TRUCK, AMBULANCE, LIGHT, 4 LITTER, FFR, WINCH,
MC2-LAND ROVER 110 6X6

FITTING OF A SUPPORT BRACKET TO THE AIR
CONDITIONER COMPRESSOR HOSES

MODIFICATION INSTRUCTION

Figure 1 - Air Conditioner Hose Support Bracket

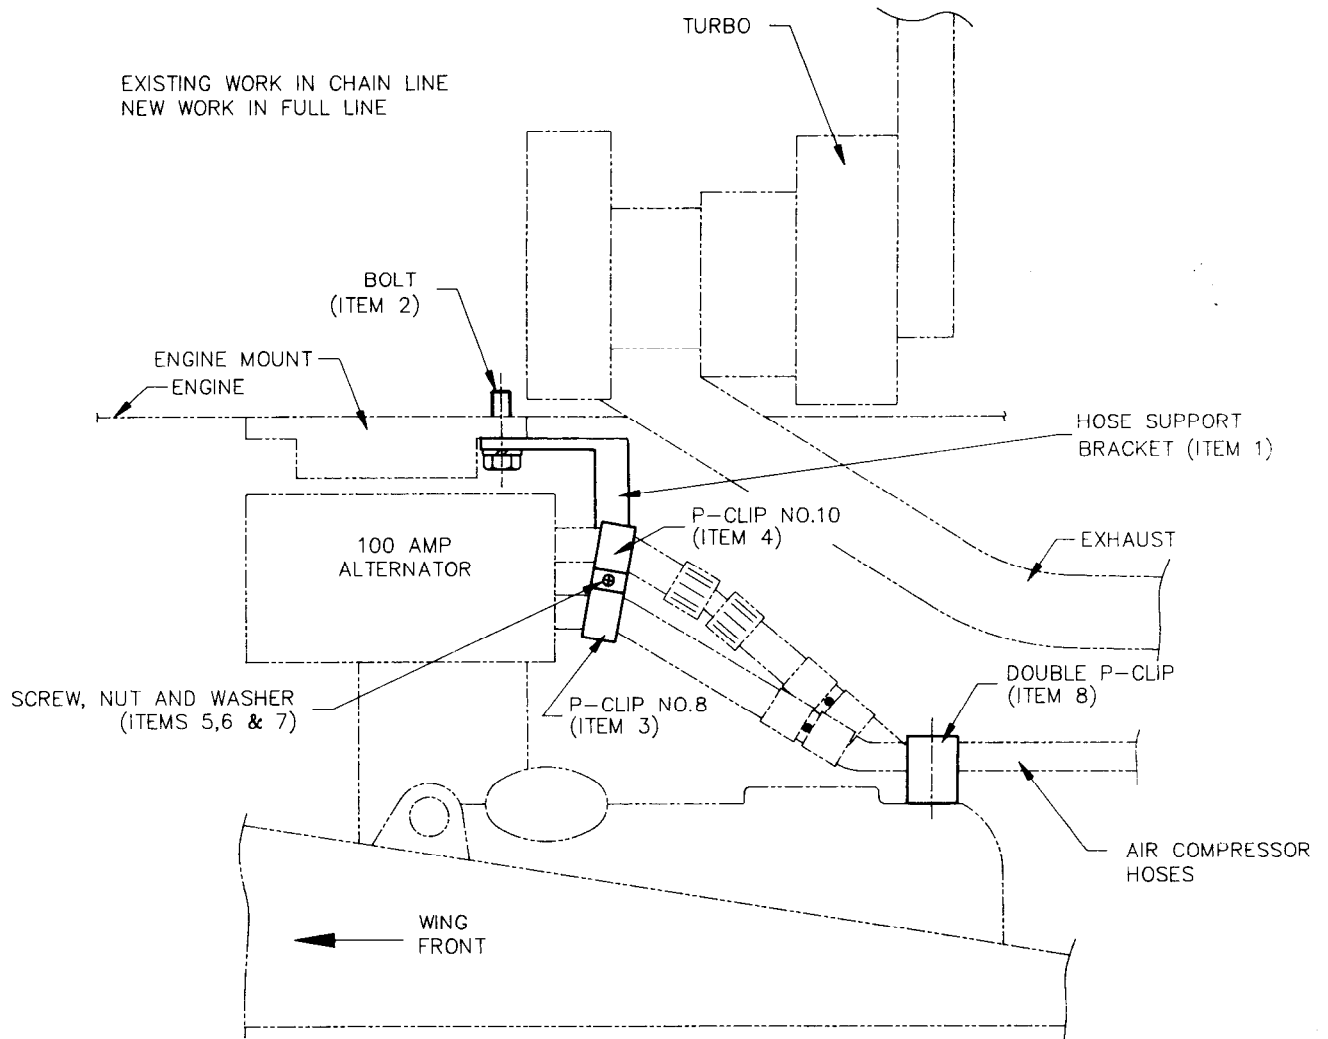
1. This instruction details the fitting of a support bracket to the air conditioner compressor hoses to reduce vibration and subsequent breakage of the hose unions. The instruction is to be read in conjunction with VEHICLE G 229-1, which details replacement of the current air conditioner hoses, on failure.

11. The modification is to be carried out as follows, with reference to Fig 1 for component location.

- Inspect the airconditioner hoses and replace damaged hoses as detailed in Vehicle G 229-1.
- Remove the two rearmost bolts from the LHS front engine and alternator mounting bracket.
- Fit the support bracket (item 1) to the engine mount using new longer mounting bolts (item 2)(the aircon hoses should be resting on top of the bracket at this stage).
- Fit the "P" clips (item 3 and 4) to the hoses and attach the clips to the support bracket using screws, nuts and washers (item 5,6,7).

e. Fit the double "P" clip (item 8) around the aircon hoses adjacent to the exhaust pipe and fit to existing bolt.
